Figure 15. Top and power

Title: TOP & POWER		
Project: NUCLEO-XXXXXX		
Size: A4	Reference: MB1137	Revision: B-01
Date: 8/19/2016	Sheet: 1 of 6

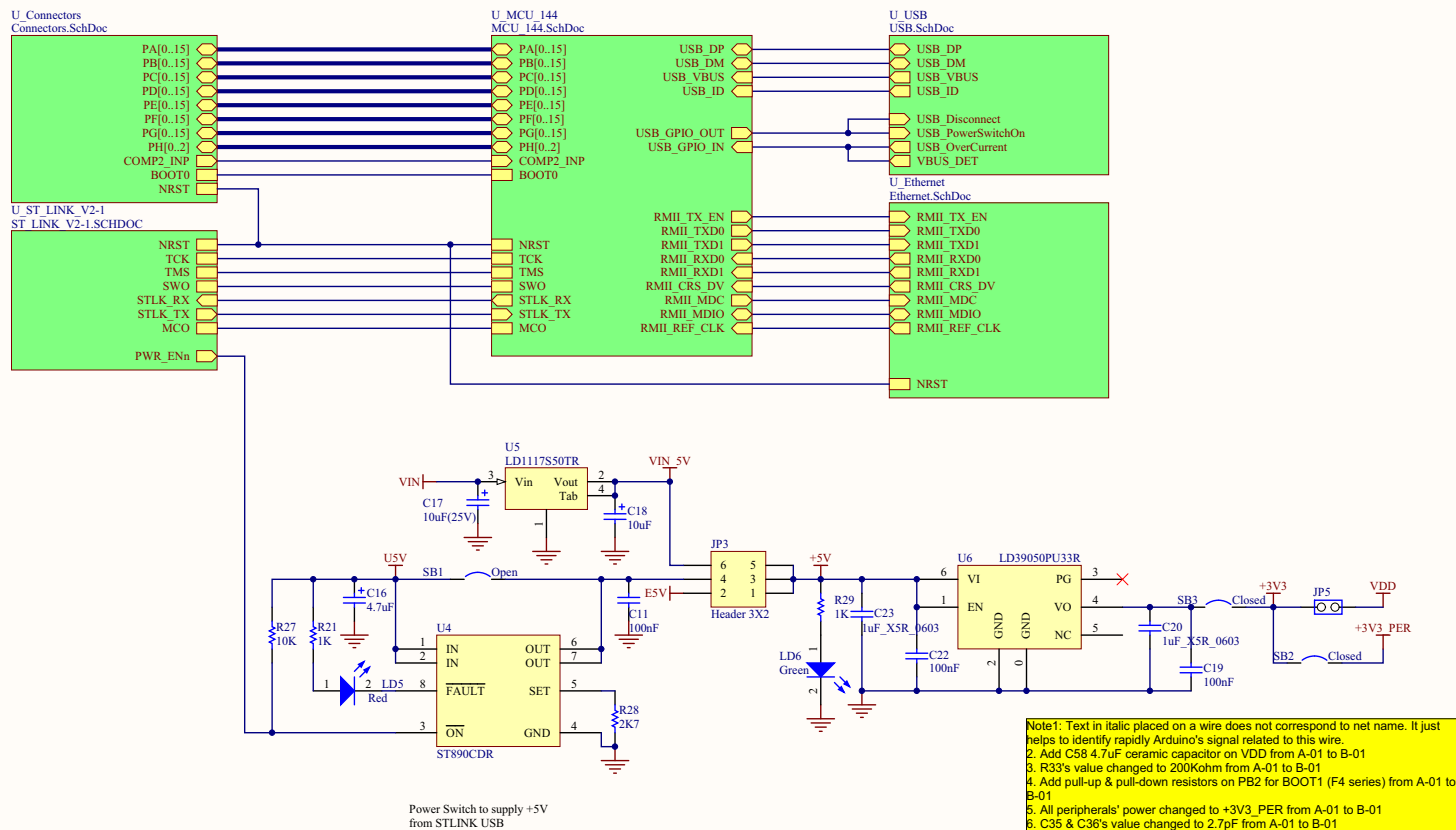
Note1: Text in *italic* placed on a wire does not correspond to net name. It just helps to identify rapidly Arduino's signal related to this wire.
 2. Add C58 4.7uF ceramic capacitor on VDD from A-01 to B-01
 3. R33's value changed to 200Kohm from A-01 to B-01
 4. Add pull-up & pull-down resistors on PB2 for BOOT1 (F4 series) from A-01 to B-01
 5. All peripherals' power changed to +3V3_PER from A-01 to B-01
 6. C35 & C36's value changed to 2.7pF from A-01 to B-01
 7. Add R76 1.5K pull-up circuit to USB_DP for F303ZE only from A-01 to B-01
 8. LD1 can be controlled by PB0 from A-01 to B-01
 9. D11 on CN7 can be set to PB5 from A-01 to B-01
